January 16, 2009

Docket No. 52-021  
MHI Ref: UAP-HF-09002

**Subject: MHI's Partial Responses to the NRC's Requests for Additional Information on Topical Report MUAP-07013-P (R0) "Small Break LOCA Methodology for US-APWR"**

Figure RAI-7-1.2 ECC water flow from the high head safety injection systems

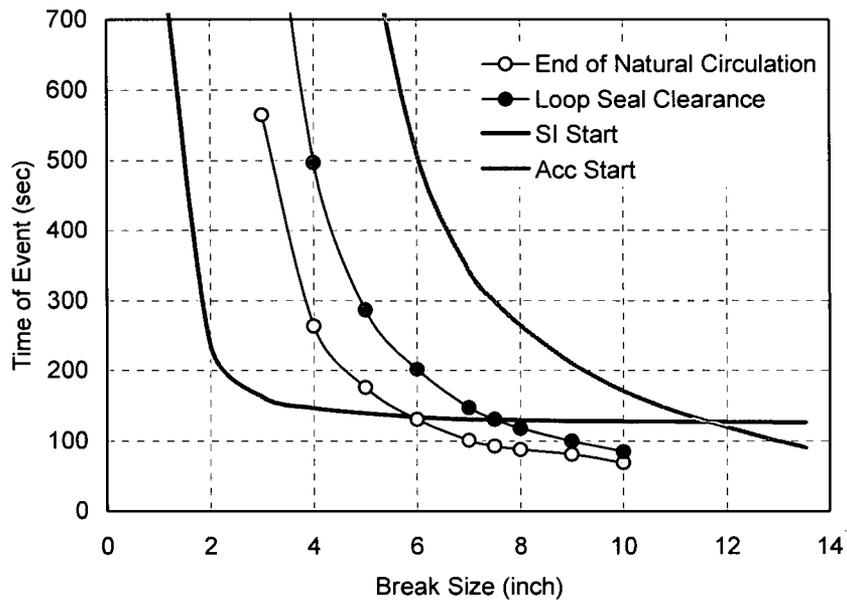
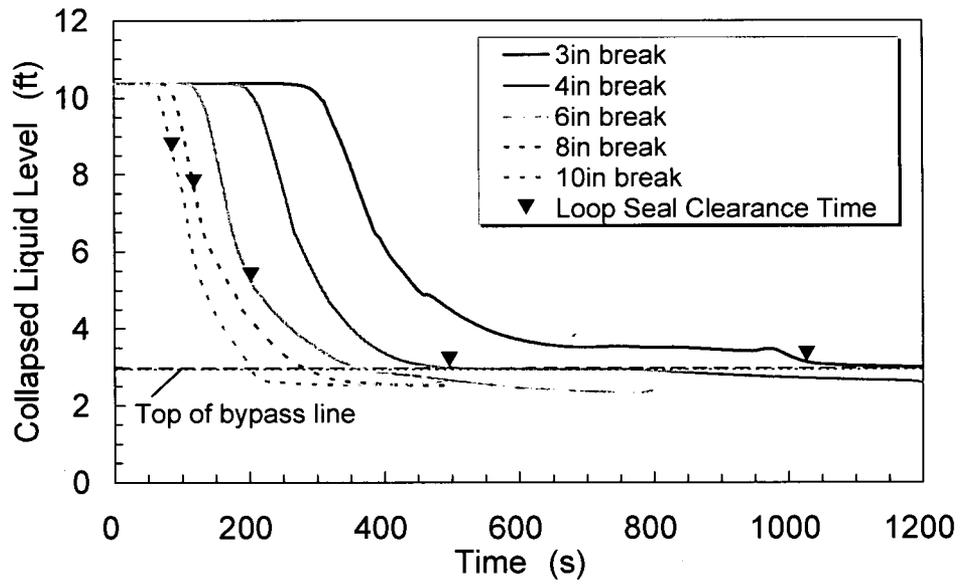
Appendix K requirement #15 ECC water bypass is taken as not applicable to SBLOCA. The bypass flow between upper head and downcomer could potentially provide a path for steam to enter the downcomer during the loop seal clearance period. Confirm that none of the SBLOCA analyses, including sensitivity cases, experience the effect of steam impeding ECC flow.

As the loops are sealed at the cross-over legs during the loop seal clearance period, upper head/downcomer bypass flow path has the potential for relieving vapor generated in the core. The break size spectrum analyses for the cold leg break are performed for US-APWR (Ref.1). The loop seal clearance periods for various break sizes are shown in Figure RAI-7-1.1. The assumed break orientation for these cases is the bottom of the cold leg. ECC water injection start time of the high head safety injection systems and the accumulators are also shown in Figure RAI-7-1.1. Only the high head safety injection system injects ECC water during the loop seal clearance period.

ECC water from the high head safety injection systems is injected into the downcomer in the downward direction between the vessel wall and the barrel wall through the direct vessel injection line shown in Figure RAI-7-1.2. So, even if the steam flow through the bypass line exists, it does not impede ECC flow into the core.

The collapsed liquid level transients in the vessel upper head and the end of the loop seal clearing period for several break sizes are shown together with top of bypass line elevation in Figure RAI-7-1.3. The bypass line is covered by the water during the loop seal clearance period. So, the vapor generated in the core hardly escape to the downcomer through the bypass line.

Figure RAI-7-3.1 M-RELAP5 noding scheme

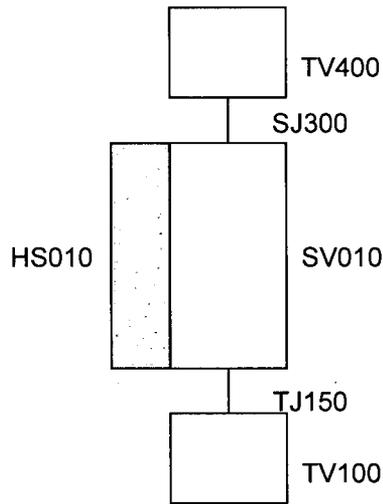
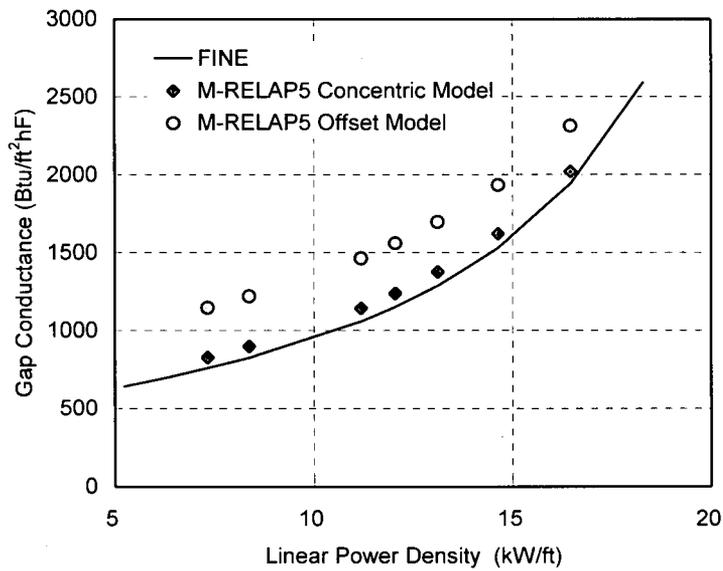
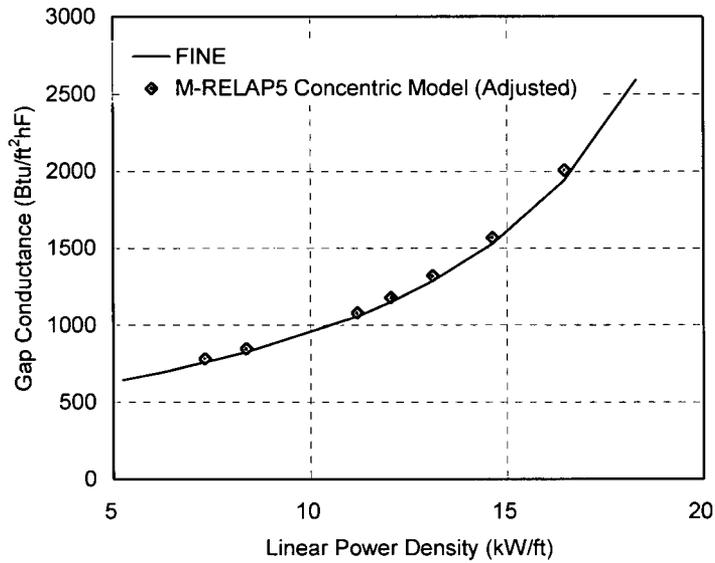
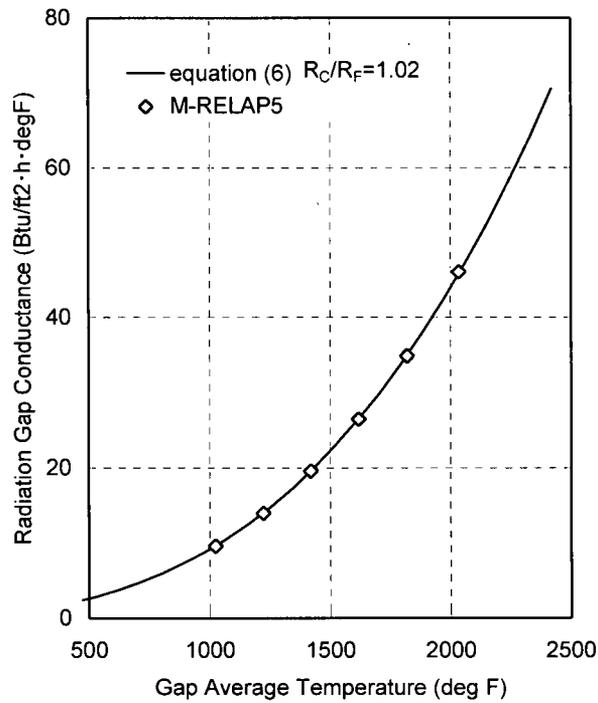
The discussion of gap conductance model is in the form of one equation and one reference to the fuel design code FINE. Provide validation analysis of the gap conductance model as expressed in Equation (7.1.2-1). Provide verification of the implementation of the gap conductance model in M-RELAP5 and demonstrate the integration of the gap conductance model with the rest of the gap heat transfer model in RELAP5-3D, such as thermal radiation across the gap.

M-RELAP5 nodding scheme is shown in Figure RAI-7-3.1. Heat structure HS010 represents a fuel rod, and single volume SV010 represents fluid volume containing the fuel rod. Vapor temperature of time dependent volume TV100 is selected so that the calculated cladding surface temperature agrees with that predicted by FINE. Pressure of time dependent volume TV400 is adjusted to make the SV010 pressure to be 2250psia. Internal pressure calculated by FINE is used in M-RELAP5. The input values for surface roughness of the fuel and cladding for M-RELAP5 are selected so that the effect of surface roughness on gap conductance is same between M-RELAP5 and FINE.

The comparisons of the calculated gap conductance by M-RELAP5 and FINE are shown in Figure RAI-7-3.2. The gap conductance is also calculated by M-RELAP5 using the pellet offset gap conductance model presented in equation (1). The pellet offset gap conductance model gives larger values than FINE. On the other hand, gap conductance with the concentric gap conductance model agrees with the prediction by FINE. However, a small difference remains between the two predictions. Two causes are pointed out. First, the gap conductance by M-RELAP5 includes the additional thermal radiation term across the gap. But, its contribution to the gap conductance is too small at normal conditions to explain the difference as discussed later. Next, as M-RELAP5 uses the same thermal expansion models for cladding and fuel as RELAP5-3D, the applied thermal expansion models for cladding and fuel are different between M-RELAP5 and FINE. These differences affect the predicted gap size by each code. The gap conductance calculated by M-RELAP5 is divided by the ratio of gap size calculated by FINE to gap size calculated by M-RELAP5. The obtained gap conductance agrees well with that by FINE shown in Figure RAI-7-3.3. It is concluded that the concentric gap conductance model consistent with FINE is adequately implemented in M-RELAP5.

M-RELAP5 uses the same thermal radiation term as RELPA5-3D. Radiation gap conductance mainly depends on the gap average temperature, and slightly depends on the ratio of outer fuel radius to inner cladding radius. Radiation gap conductance dependency on the average gap temperature is shown in Figure RAI-7-3.4.

Fuel rod temperatures are increased by setting the vapor temperature of time dependent volume TV100. The obtained radiation conductance is shown in Figure RAI-7-3.4. It agrees with the prediction with equation (6). It is concluded that the radiation conductance model across the gap is adequately implemented in M-RELAP5.

Figure RAI-7-5.1 M-RELAP5 noding scheme

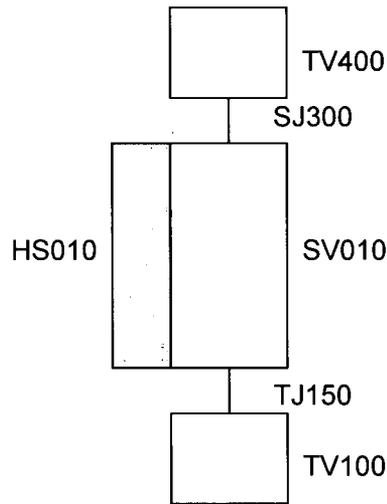
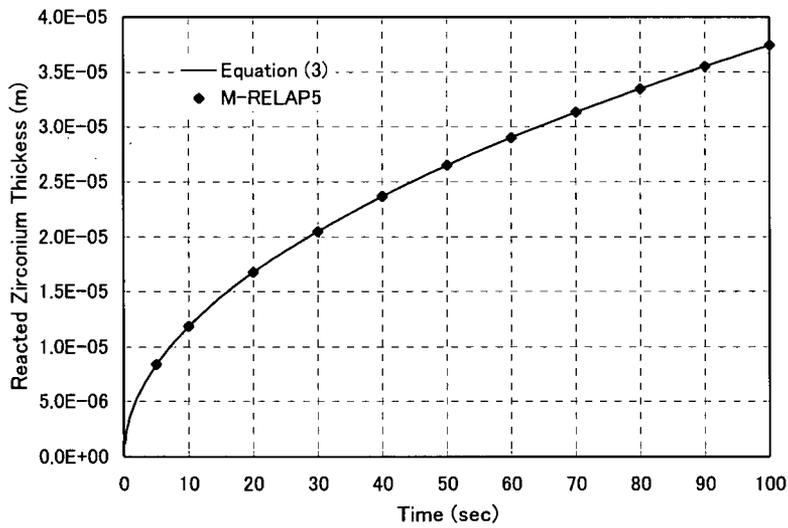
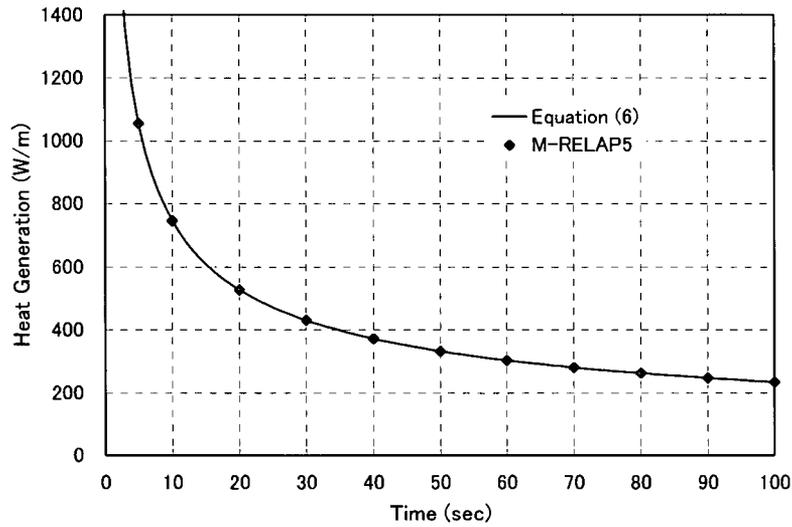
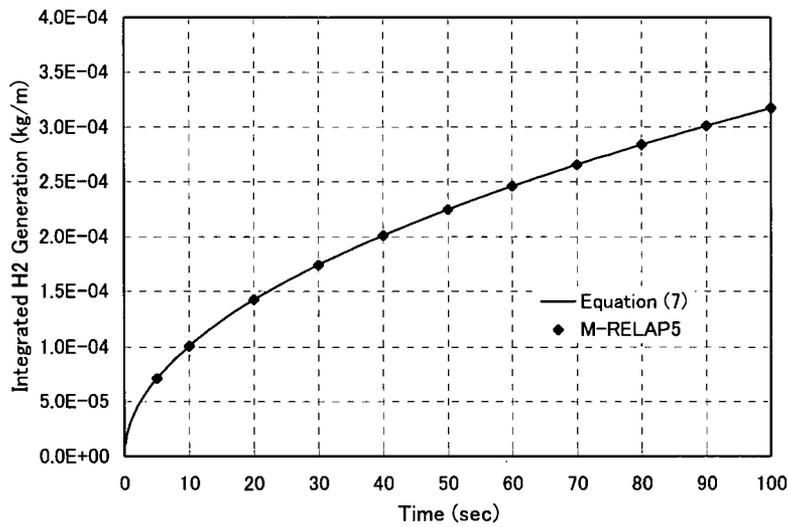
Provide verification of the implementation of the Metal Water Reaction Rate Model in M-RELAP5. Confirm that the hydrogen generation rate and the heat generation rate are consistent with the metal/water reaction rate.

The thickness of the cladding converted to oxide, the metal-water reaction heat release rate, and hydrogen mass generated by the metal-water reaction at an isothermal condition are calculated by M-RELAP5 and are compared with analytical calculation results to verify that the Baker-Just correlation is adequately implemented in M-RELAP5.

M-RELAP5 nodding scheme is shown in Figure RAI-7-5.1. Heat structure HS010 represents a fuel rod with 100mm axial length, and single volume SV010 represents fluid volume containing the fuel rod. Vapor temperature of time dependent volume TV100 is set to be 1200 deg C and junction vapor flow of time dependent junction TJ150 is set to be  $1.0 \times 10^6$  kg/s to maintain the cladding surface temperature at 1200 deg C. Fluid pressure is maintained to be 10MPa by time dependent volume TV400. Fission and decay heat power are neglected and a large rod surface heat transfer coefficient is applied so that the metal-water reaction heat rate can be estimated from the heat transfer rate from cladding to vapor. Cladding swelling and rupture calculations are skipped so that the M-RELAP5 and analytical results can be easily compared.

The comparisons of the calculated results of the zirconium reacted thickness, the reaction heat release rate and the hydrogen mass generated by M-RELAP5 with the results by equation (3), equation(6) and equation (7) are shown in Table RAI-7-5.1 and Figure RAI-7-5.2, Figure RAI-7-5.3 and Figure RAI-7-5.4. The calculated results by M-RELAP5 agree with the results by the analytical method well. It is concluded that the Baker-Just correlation is adequately implemented in M-RELAP5 and the hydrogen generation rate and the heat generation rate are also adequately calculated.

Figure RAI-8.1.3-8.1 Heat Transfer and Hydraulic Flow Regimes for Bottom Reflood (Ref.2)

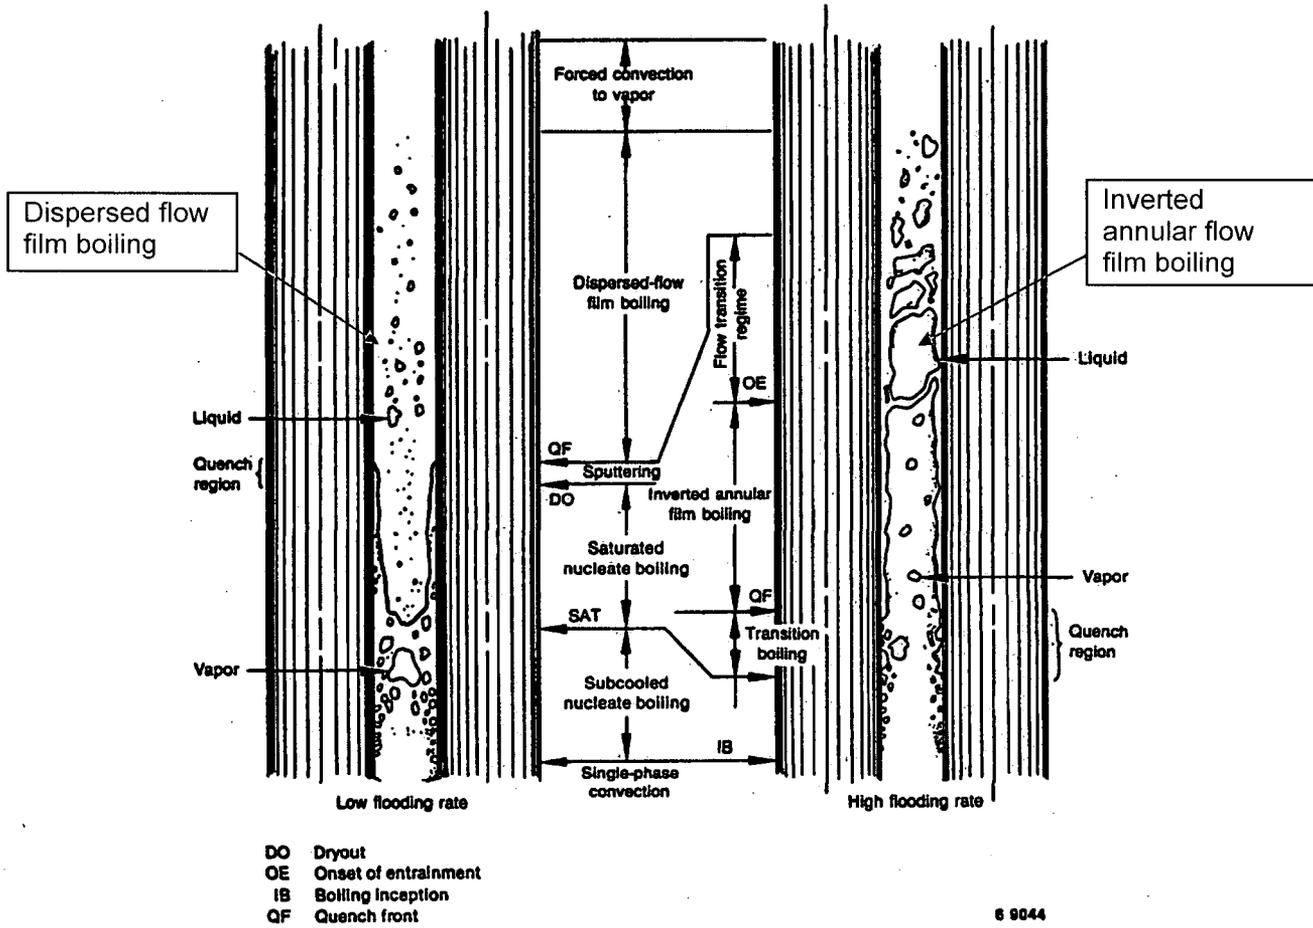
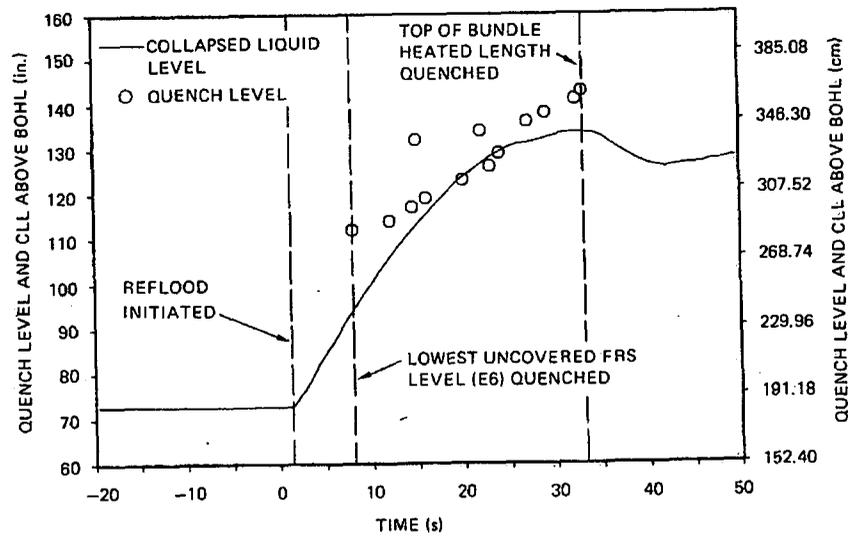
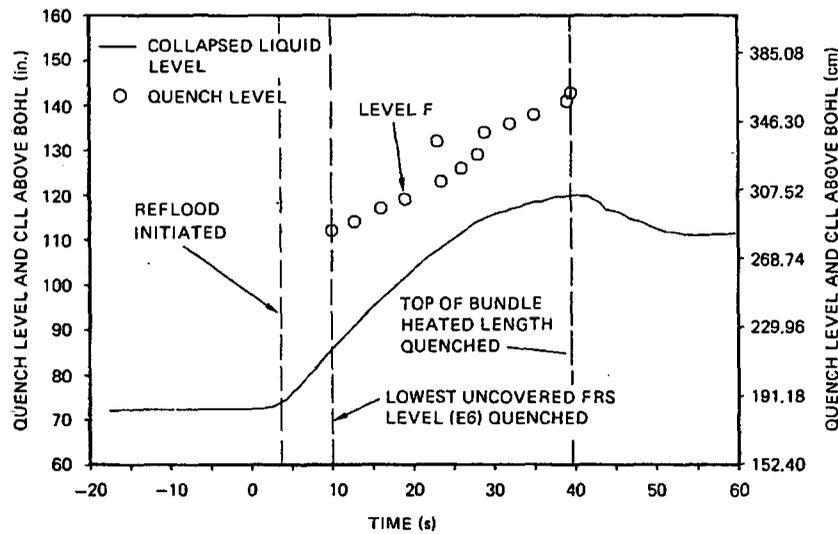
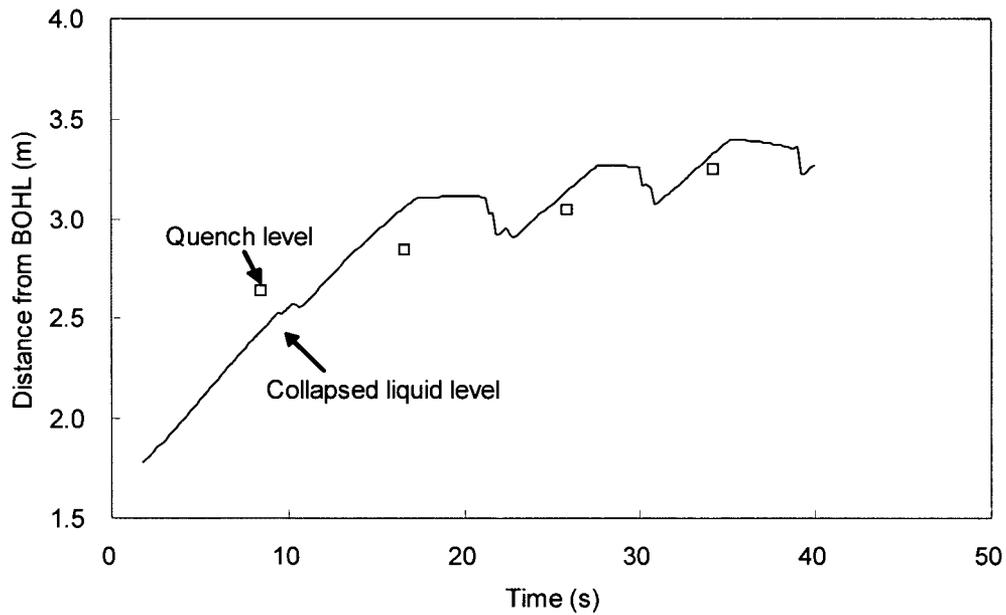
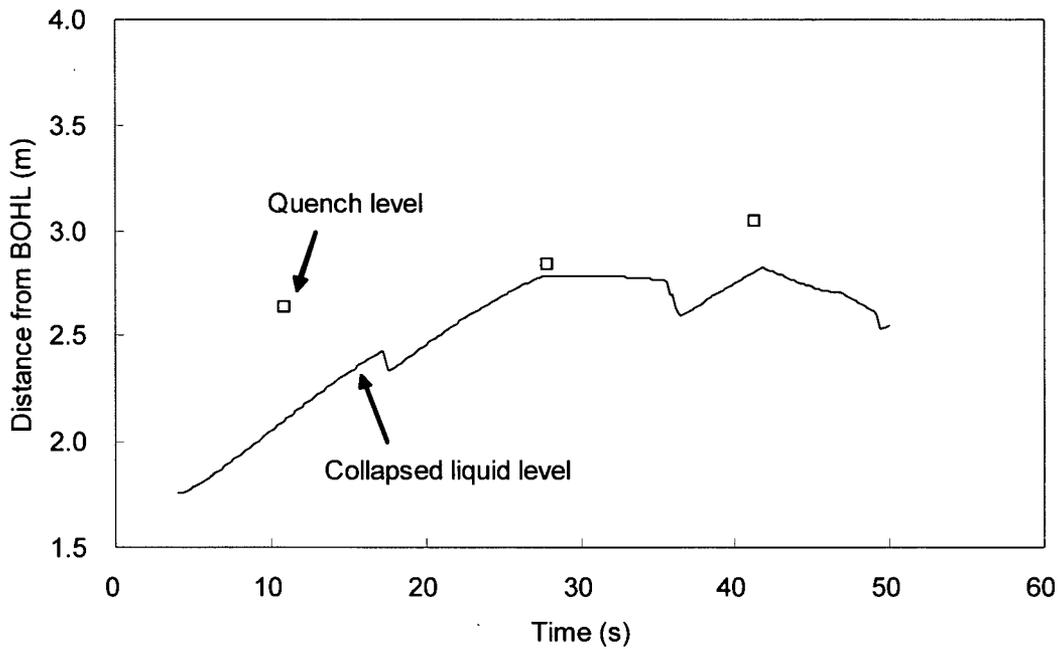
The quench velocities for test P (Figure 8.1.3-11) and test Q (Figure 8.1.3.15) are similar for the tests (about 3 cm/sec for P and 2.8 cm/sec for Q), but they are substantially different for the simulations (about 2.4 for P and 1.3 for Q). This may imply that the quench velocities for the simulation could be higher than the test for some parameter ranges, and thus the simulation may not be conservative. Please explain.

When the quench level is significantly above the collapsed liquid level, dispersed flow film boiling is suggested, while the inverted annular film boiling may be suggested when the quench level is near or below the collapsed level. These heat transfer and hydraulic flow regimes are schematically compared in Figure RAI-8.1.3-8.1 (Ref.2). Next, Figures RAI-8.1.3-8.2 and 3 show comparisons between the measured quench level and collapsed level histories for Tests P and Q, respectively, indicating that the dispersed flow film boiling possibly appeared in Test Q rather than Test P. Under the dispersed flow film boiling like Test Q, numerous droplets occur from the liquid level front, which effectively contribute to the precursor cooling above the liquid level before quench. This effectively decreases the vapor superheat and the fuel rod surface temperature in the uncovered-bundle region, and thus hastens the quench rate even though the flooding rate is low. This is why the difference in the measured quench rates between Tests P and Q was relatively small, in spite of the fact that the flooding rates were significantly different from each other.

Figures RAI-8.1.3-8.4 and 5 show comparisons between the collapsed and quench levels calculated by M-RELAP5 for Tests P and Q, respectively. The precursor cooling effect predicted by M-RELAP5 is significantly less than the measurement for Test Q. Figures RAI-8.1.3-8.6 and 7 show the axial distributions in terms of the applied heat transfer mode and computed heat transfer coefficient by M-RELAP5 for Tests P and Q, respectively. It is found that the dryout heat transfer coefficient just above the quench front in Test Q is reduced to [ ], due to the heat transfer mode different from Test P.
